APPEAL SUMMARY

Appeal ID: 22163	Project Address: 1525 SW Park Ave
Hearing Date: 12/11/19	Appellant Name: Amy Ely
Case No.: B-002	Appellant Phone: 503-243-1109
Appeal Type: Building	Plans Examiner/Inspector: Preliminary
Project Type: residential	Stories: 12 Occupancy: R-2 Construction Type: A
Building/Business Name: Southpark Square Apartments	Fire Sprinklers: Yes - Apt interiors,
Appeal Involves: Correction of a violation	LUR or Permit Application No.: Tax ID 27-1776065
Plan Submitted Option: mail [File 1]	Proposed use: Multi-Family Housing/Commercial Space

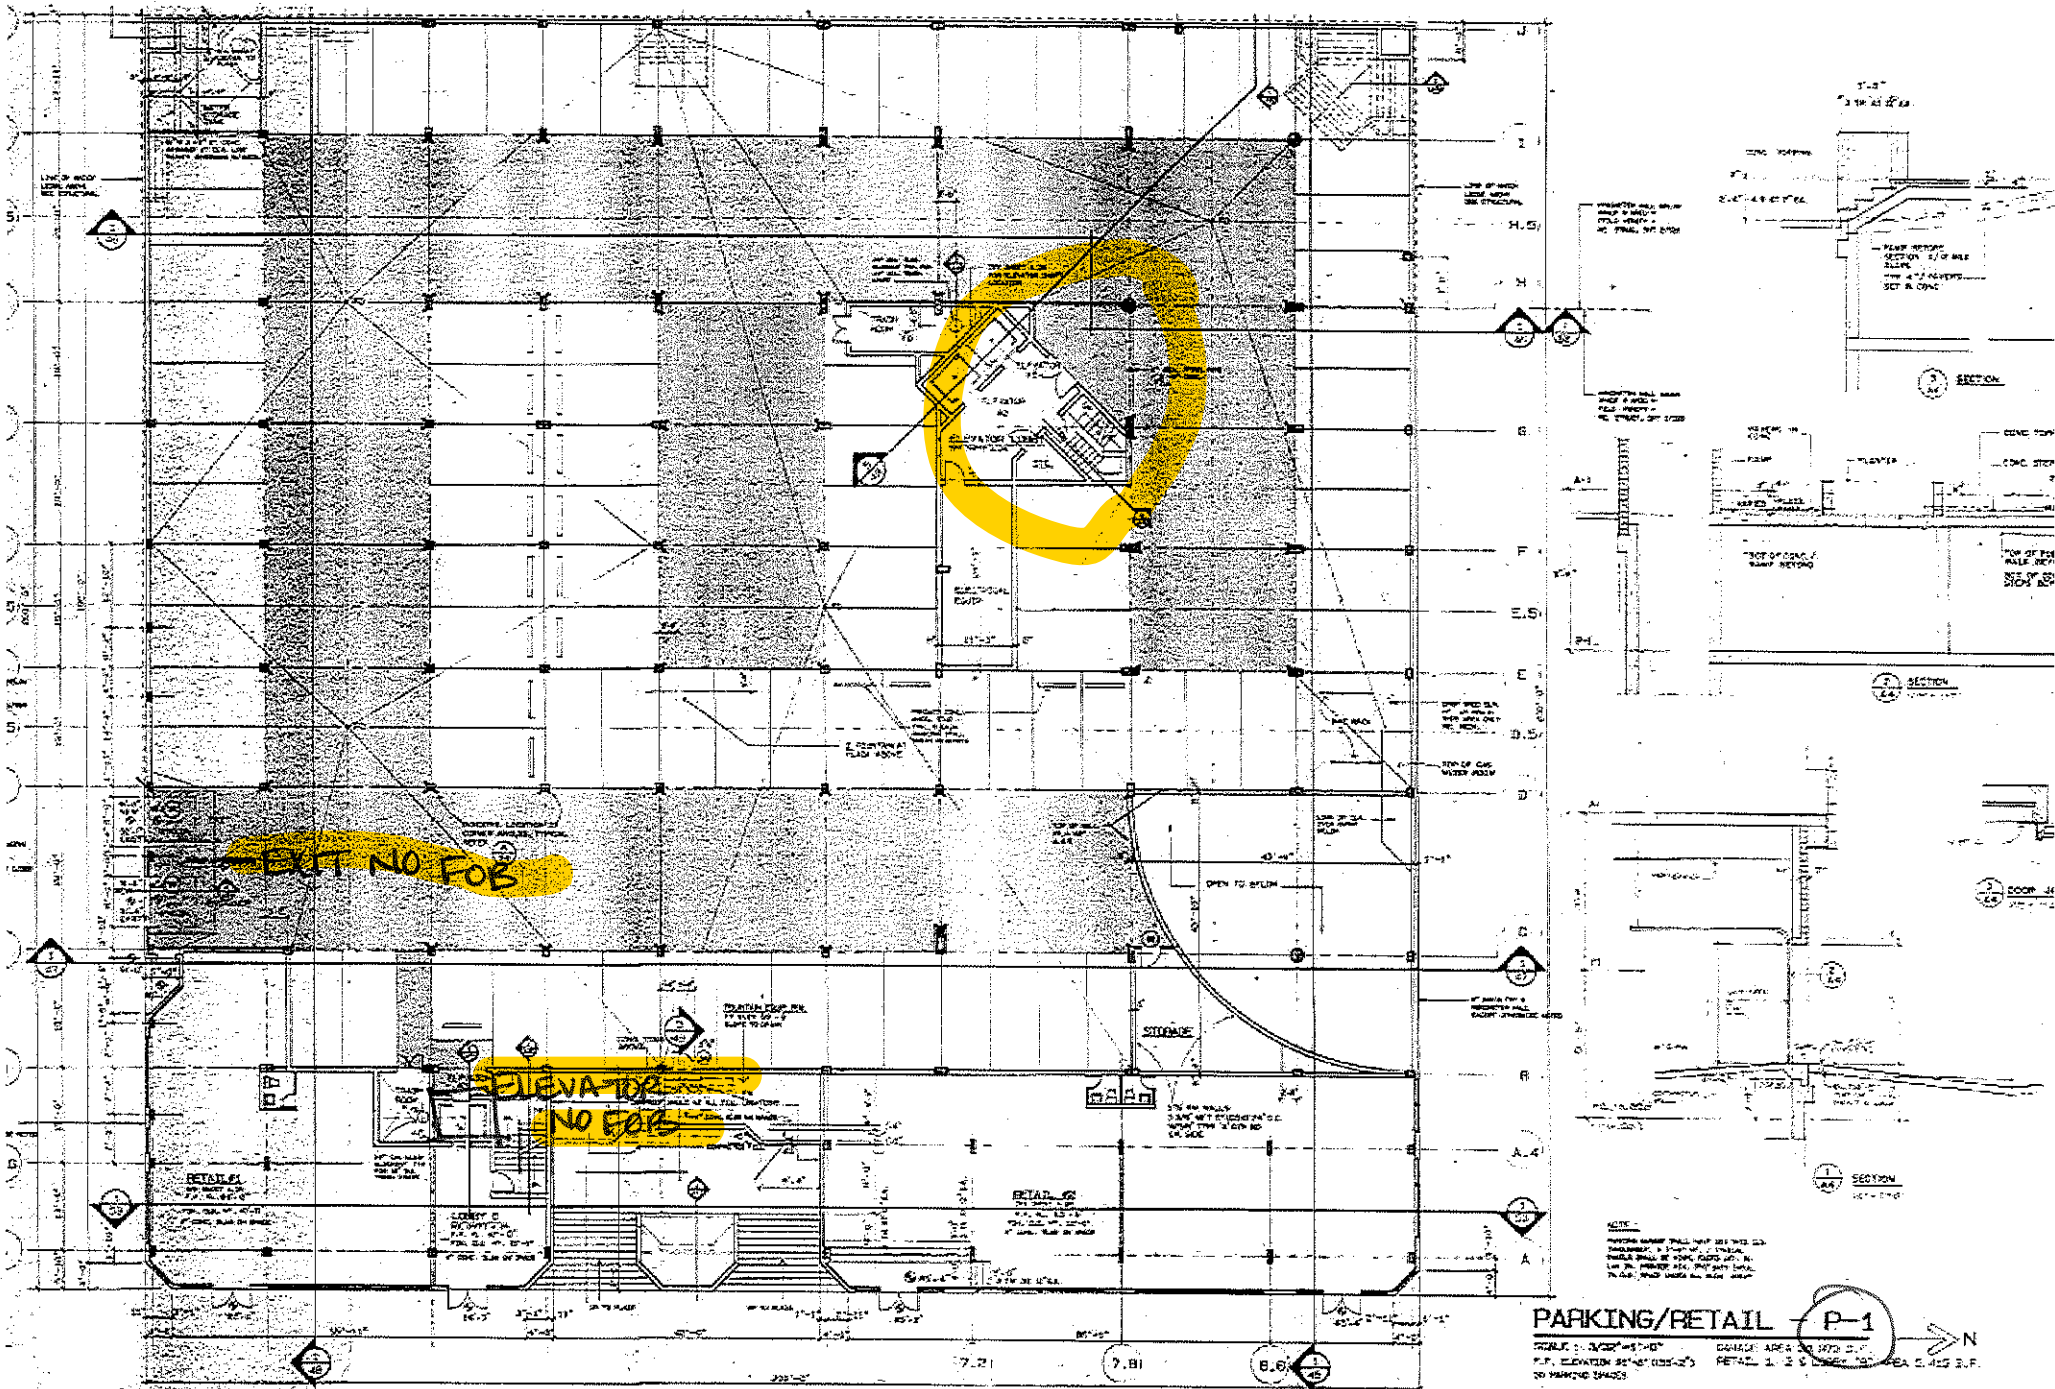
Proposed Design Alternative exits without controlled access fobs are available to non-residents.

Reason for alternative The building owner has a need to secure the building entrances in the parking garage. This is important to ensure the safety of the residents against potential intruders who may cause harm or damage to the residents or to the building. Egress from the parking garage area is also required.

Controlled egress locks at doors in the parking levels leading to the elevators discourage intruders from entering the building. Egress is provided through the use of the manual unlocking device described in condition 3 of OSSC section 1008.1.9.8. A building occupant has the ability to exit the parking garage by activating the manual unlocking device, which unlocks doors, allowing for free egress into the building.

Egress from the parking garage is provided due to loss of power to the access control system, activation of the fire alarm, activation of the fire sprinkler system. Additionally, there are alternative exits allowing for egress from the parking garage that do not have controlled access and provide egress to the exterior of the building and does not jeopardize the security of the residents.

Condition 1 of OSSC section 1008.1.9.8, which requires a motion sensor on the egress side of the door, does not apply to this case. If a motion sensor or emergency release button were installed on the egress side of doors it would override the card reader and allow potential intruders to enter the building. A motion sensor on the egress side of these doors would render the controlled egress locks and manual unlocking devices useless. Condition 1 of OSSC section 1008.1.98 would not provide a greater level of fire and life safety in this particular condition. It would eliminate any possibility of providing security for the residents of the building. Therefore we believe that motion sensors should not be required on the egress side of the exit doors.

Electro-magnetic lock at Egress Doors from Parking Garage into tenant spaces: Granted provided signage is posted at locked doors identifying location of exits.
Appellant may contact John Butler (503 823-7339) with questions.

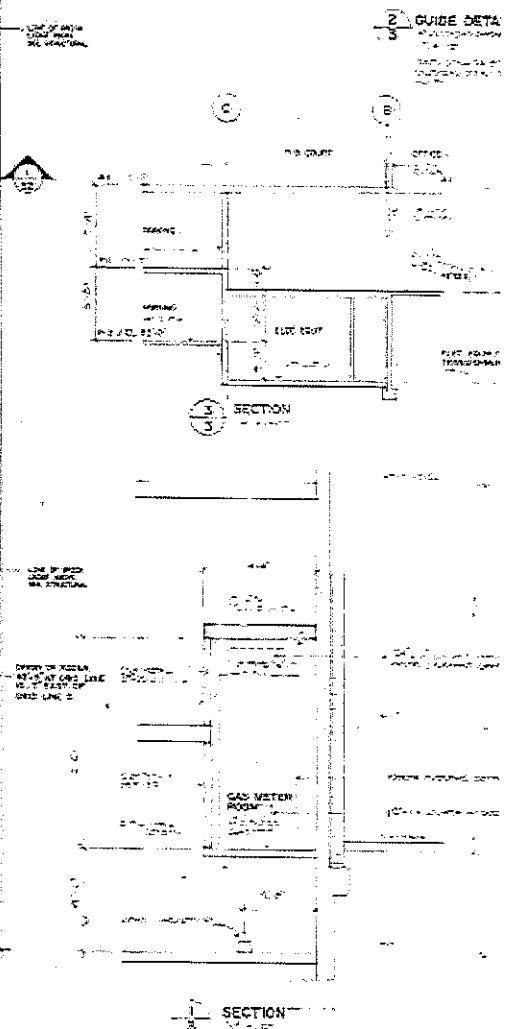
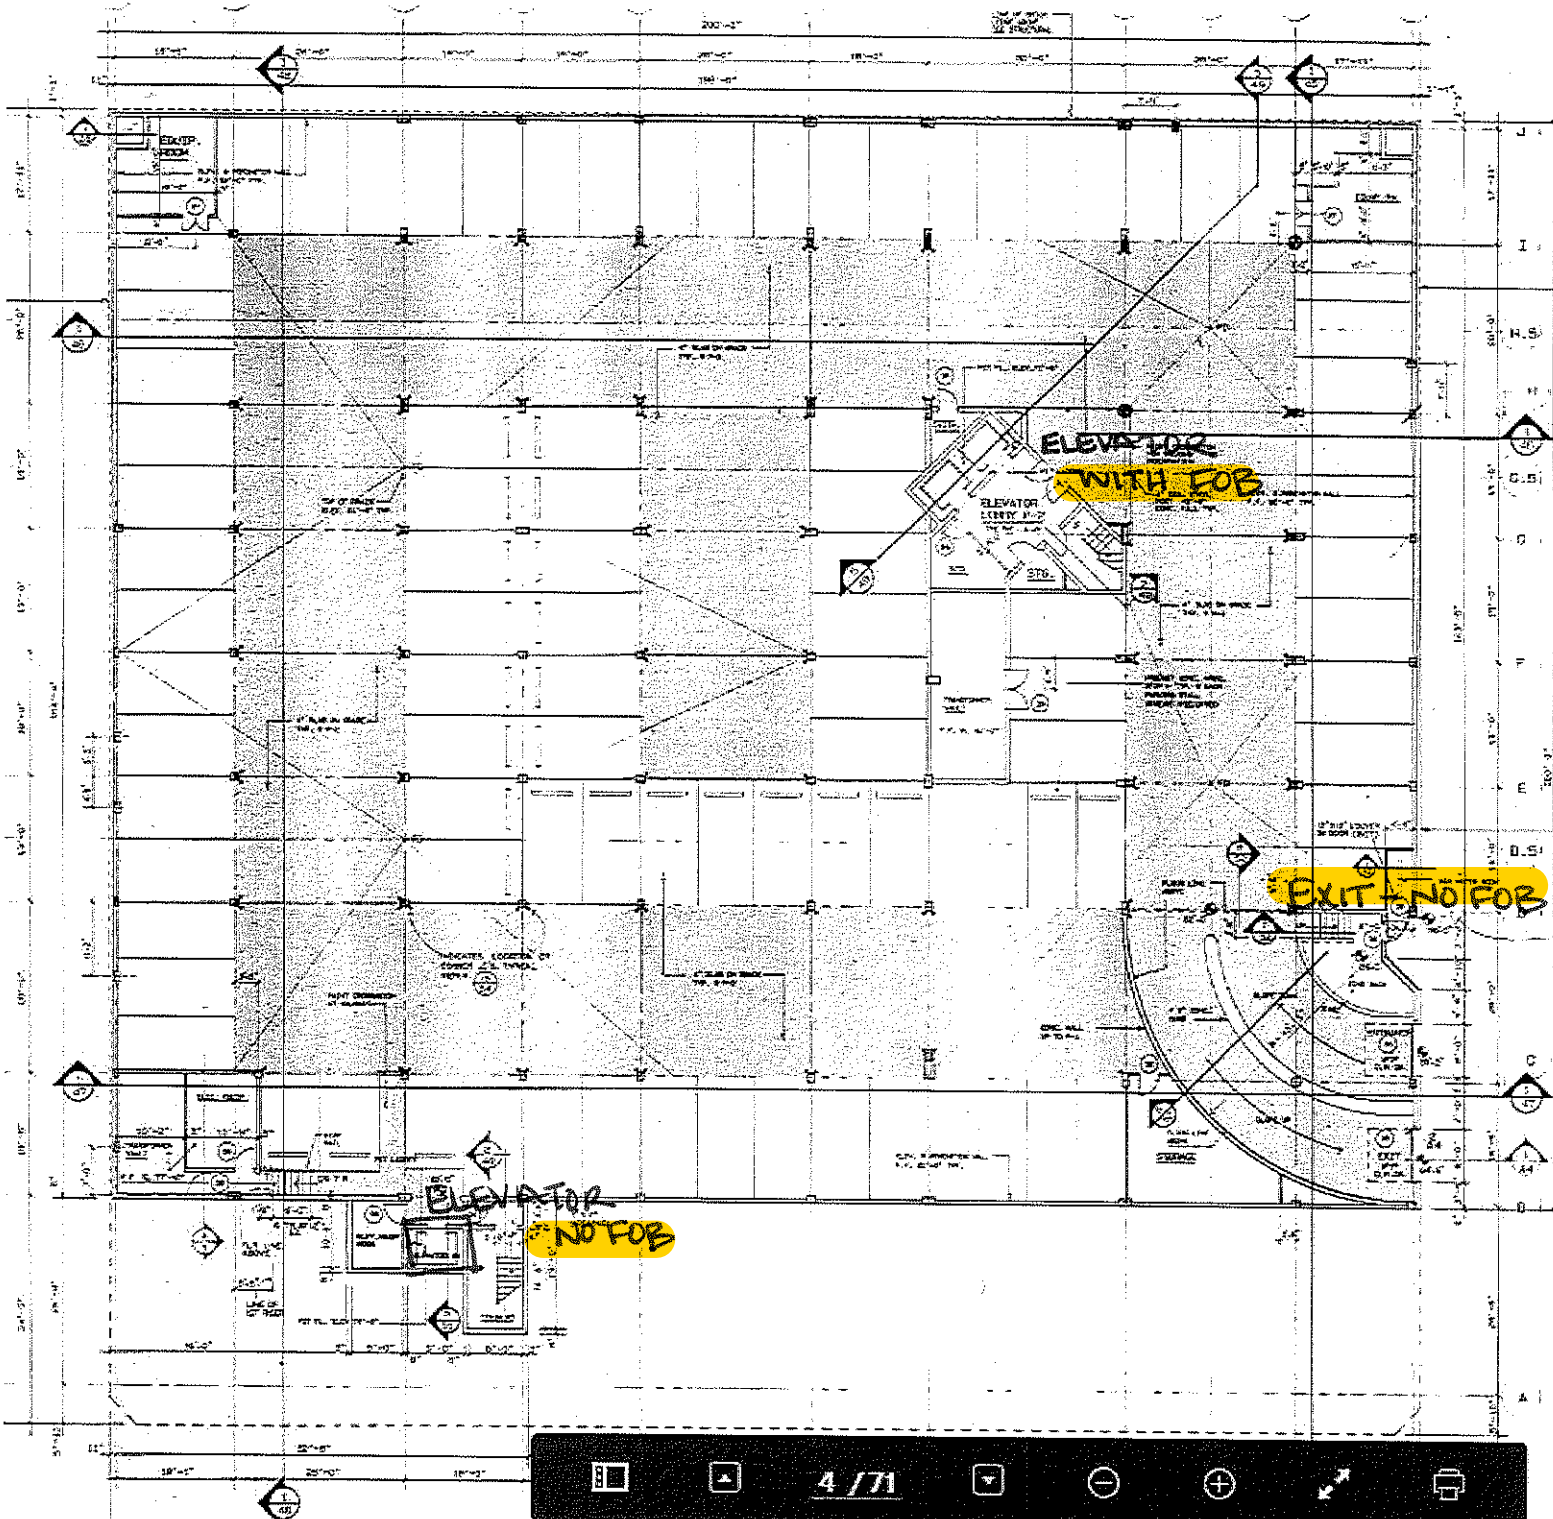
An unsecured building entrance would be a less safe condition for the occupants of the building due to the harm or damage that could be caused by intruders who have no barriers to entering the building.
